Re: Publication of the Responses to Comments document for the  
**706 Mission Street – The Mexican Museum and Residential Tower Project**  
Department File No. **2008.1084E**

CITY AND COUNTY OF SAN FRANCISCO  
PLANNING DEPARTMENT: CASE NO. 2008.1084E

DATE: March 7, 2013  
TO: **Members of the Planning Commission and Interested Parties**  
FROM: **Sarah Jones, Acting Environmental Review Officer**  
Re: **Attached Responses to Comments on Draft Environmental Impact Report Case No. 2008.1084E, 706 Mission Street – The Mexican Museum and Residential Tower Project**

**FIGURE RTC.1: VIEW K – VIEW TO PROJECT SITE FROM YERBA BUENA GARDENS PEDESTRIAN BRIDGE OVER HOWARD STREET, LOOKING NORTHEAST**

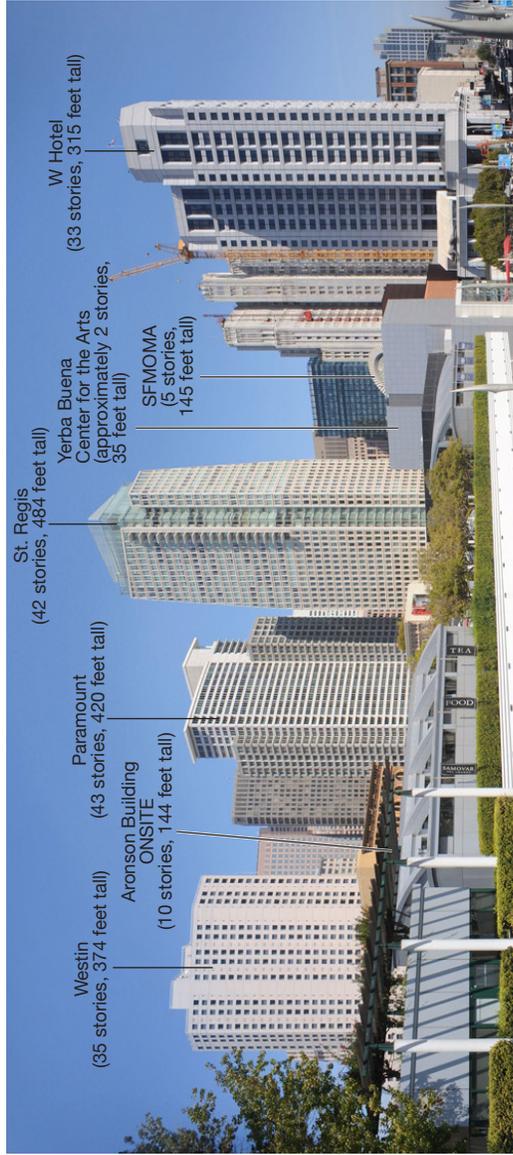
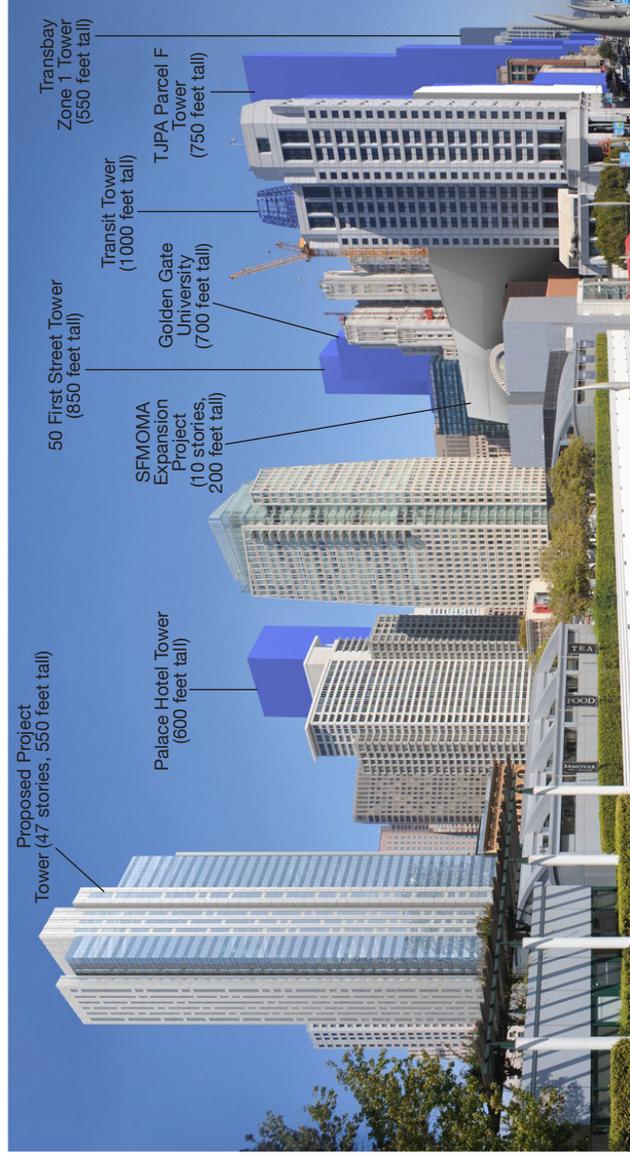
One thing which the EIR unfortunately does not do – and it’s extremely important to me personally – is a visual analysis of other new buildings which are already approved, such as the Museum Tower, which will change the skyline in this area. I think the visual analysis needs to include a view coming from the south of Third Street and take a look at what it looks like with the new Museum Tower and this tall proposed building. (*Commissioner Kathrin Moore, San Francisco Planning Commission*)

And then, finally, what Commissioner Moore brought up, looking at cumulative, looks visually at the expansion of the MOMA and perhaps some visualization with new buildings that we would assume are going to be in place, have already been approved, some of which might be close to going under construction; might be good to at least note that a little bit and see what the appearance looks like when those are in place. (*Commissioner Michael Antonini, San Francisco Planning Commission*)

Comments request that a photosimulation and analysis be provided to address the cumulative visual impact of the proposed project together with nearby approved, but not yet constructed, projects like the San Francisco Museum of Modern Art (SFMOMA) Expansion Project (at 151 Third Street) and potential development allowable under the Transit Center District Plan to the east of the project site. In response to this comment, Figure RTC.1: View to Project Site from Yerba Buena Gardens Pedestrian Bridge over Howard Street, Looking Northeast, is provided to show the proposed project in the context of the development envelope approved for the approximately 200-foot-tall SFMOMA Expansion Project and potential development allowable under the *Transit Center District Plan* (TCDP). This figure is shown on the following page.

Street-level, close- and mid-range views of the proposed project tower, together with approved and reasonably foreseeable potential development in the project vicinity, would be limited due to existing intervening visual barriers in the project vicinity. When viewed from the elevated Yerba Buena Gardens pedestrian bridge across Howard Street, a number of anticipated development projects would become visible within the visual setting of the proposed project. Figure RTC.1 shows the proposed project tower together with the approved SFMOMA Expansion Project (partially obscured in this view by the existing Yerba Buena Center for the Arts building). The approved SFMOMA Expansion Project will result in the construction of a 200-foot-tall new building that will house museum space and administrative offices along the north side of Howard Street, adjacent to the W Hotel.

Potential development allowable under the TCDP, which was adopted by the San Francisco Board of Supervisors on July 31, 2012, would also be visible in the background to the east of the project site within this view. The approved TCDP is a comprehensive plan and re-zoning of the southern portion of the downtown Financial District, around the site of the Transbay Terminal, and includes most of the approved Transbay Redevelopment Project Area. The TCDP increased height limits to allow for a 1,000-foot-tall Transit Tower (approved) at the former Transbay Terminal site, 700- and 850-foot-tall towers north of Mission Street within specific areas of the existing 550-S Height and Bulk District, and 700- and 750-foot-tall towers along the north side of Howard Street within specific areas of the existing 450-S and 350-S Height and Bulk Districts. Figure RTC.1 shows the proposed project tower with potential development allowable under the TCDP rising from behind existing development in the project vicinity. Shown in this figure are the following potential development projects: a 600-foot-tall tower on the southwest portion of the Palace Hotel site at 2 Montgomery Street; a 700-foot-tall tower at the Golden Gate University site at 536 Mission Street; an 850-foot-tall tower at 50 First Street; a 1,000-foot-tall Transit Tower at 425 Mission Street; a 750-foot-tall tower along the north side of Howard Street (“TJPA Parcel F”); and a 550-foot-tall tower within Transbay Zone 1 near the northwest corner of Howard and Main Streets. Potential development under the TCDP, where visible at all in views of the proposed project, would be viewed in the background and would not be prominent features within the visual setting of the proposed project, given the distance between the project site and these anticipated projects and the scale of existing intervening development which limits visual interaction between the proposed project and these anticipated projects. Under Cumulative conditions, the proposed project would be viewed in the context of a dense and varied downtown high-rise skyline. The proposed project, together with the SFMOMA Expansion Project and potential development under the TCDP, would not make a cumulatively considerable contribution to a significant cumulative impact on visual character and quality.

B.1.6

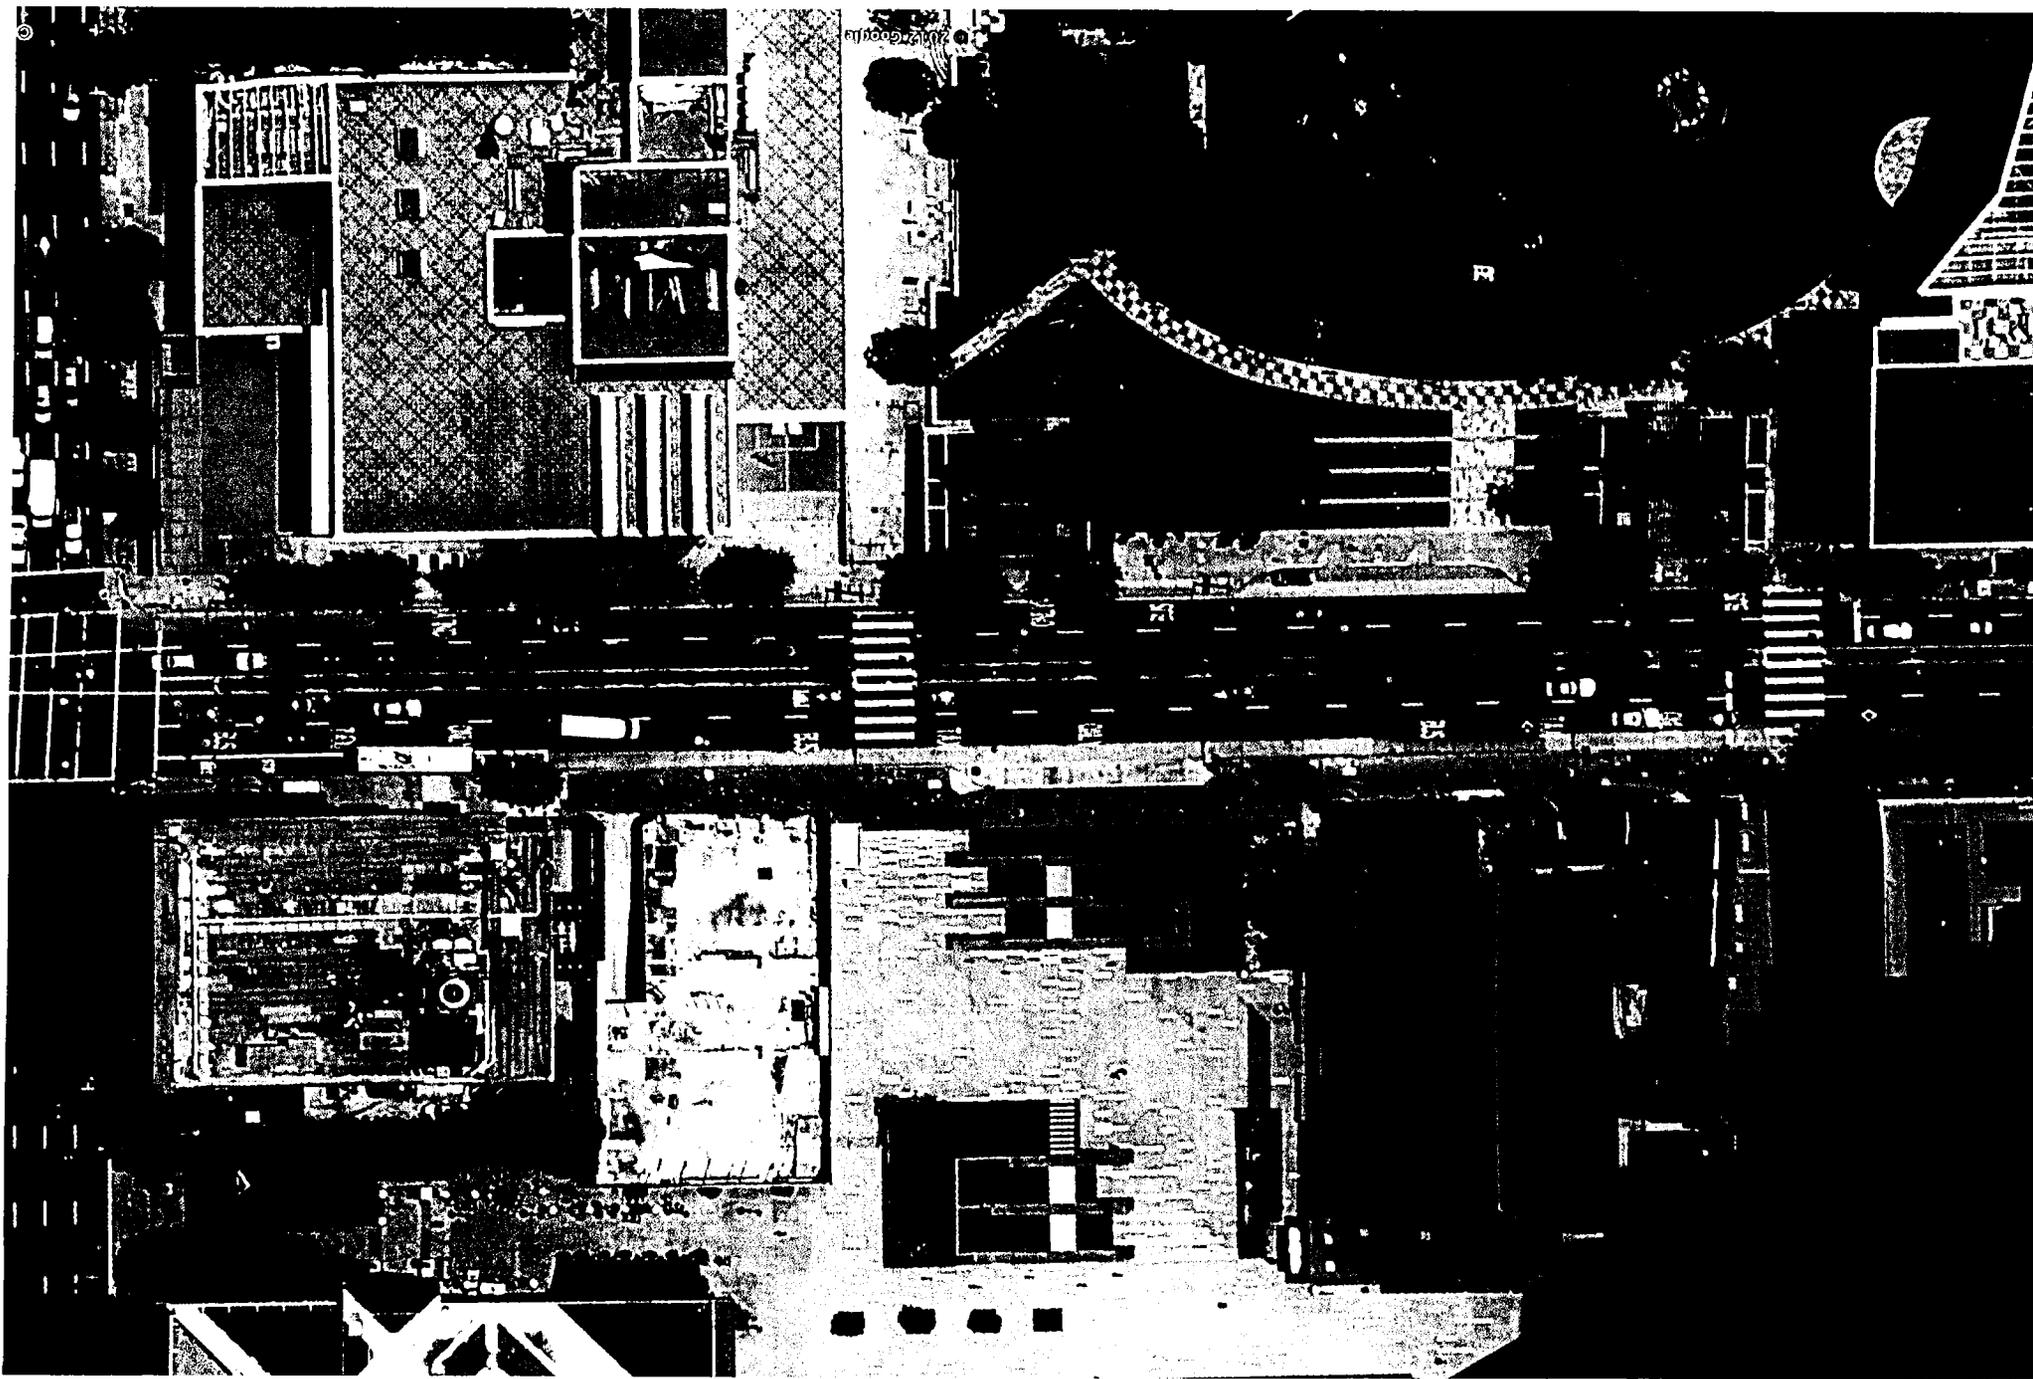
Regarding Mitigations, the original c. 1990 San Francisco Redevelopment Agency pedestrian plan for Yerba Buena Gardens to address such cumulative impacts as projected at that time and thus enhance pedestrian safety has never been fully completed. Specifically, a signalized crosswalk across Mission Street that was intended to connect the Center for the Arts/East Esplanade Walkway south of Mission Street with Jessie Square its adjacent museums north of Mission Street, mirroring the crosswalk finally installed in 1998 across Mission Street in recent years at Yerba Buena Lane to the west, was never built – initially due to opposition by the City DPT, and later due to lack of the necessary funds.

The proposed 706 Mission Project includes construction of the Mexican Museum on Jessie Square. It is self-evident that all concerned will benefit greatly from finally installing that long planned direct pedestrian crosswalk route across Mission Street, which will be directly adjacent to the Project (see diagram attached). Not only will it directly link visitor travel between the several cultural facilities on both sides of Mission Street, it will also provide at last an attractive alternate route for conventioners between Market and Howard Streets (especially if effective Moscone Center way-finding signage is also finally installed as long discussed).

Figure 1 Existing Plus Project Traffic Volumes, PM Peak Hour<sup>2</sup>

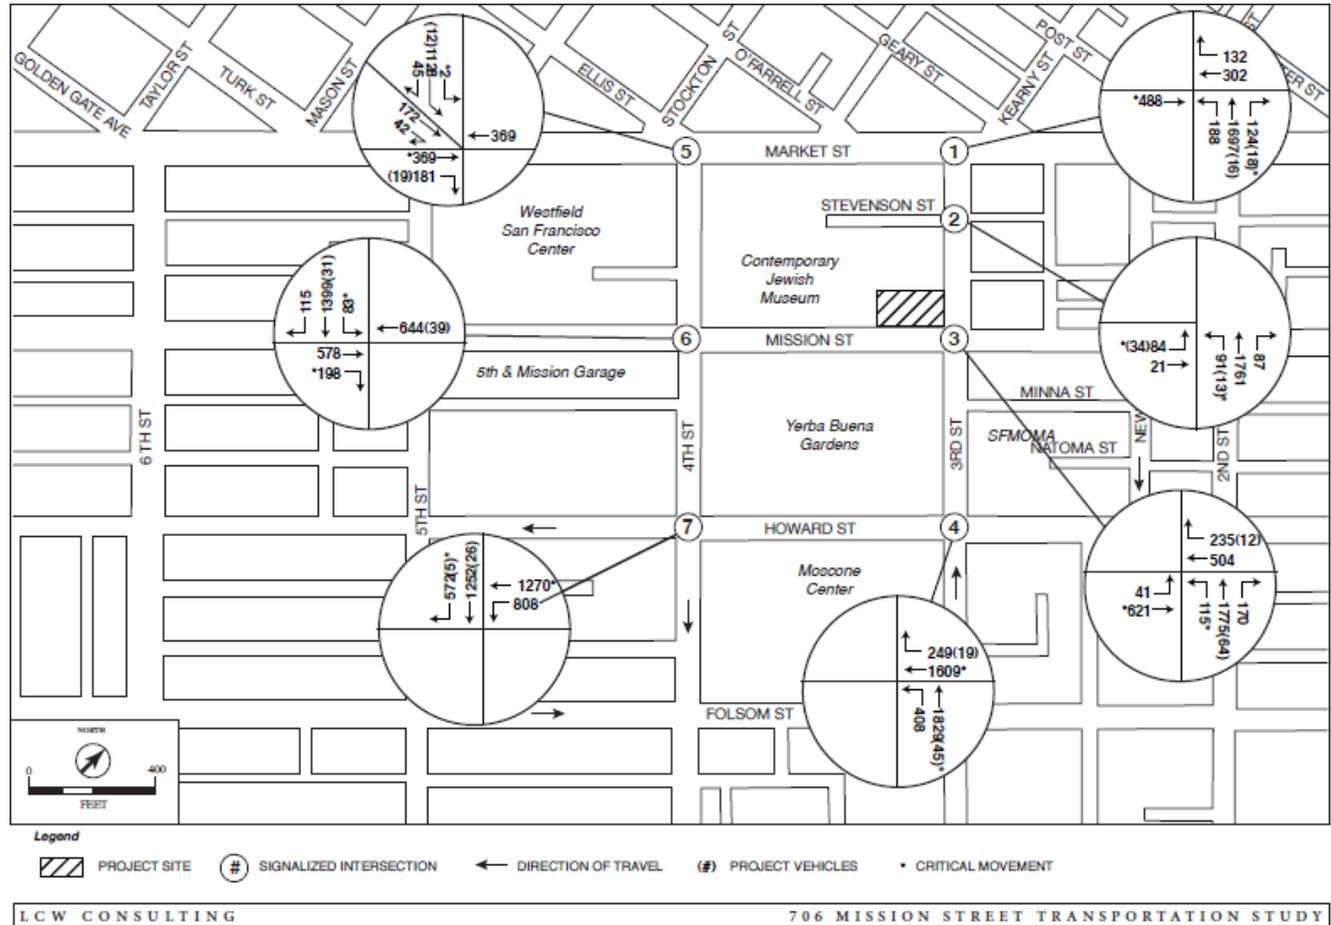
**Discussion:** The analysis of PM peak hour traffic is flawed in its determination of which movements are “critical movements” at some intersections. According to the analysis, “for an intersection that operates at LOS E or LOS F under existing conditions, there may be a significant adverse impact depending on the magnitude of the project’s contribution to the worsening of delay.”<sup>1</sup> Specifically, San Francisco traffic studies determine the level of significance in such cases based on the Project contribution to “critical movements”. Figure 1 shows the PM peak hour Existing Plus Project traffic volumes and “critical movements” as described in the DEIR.
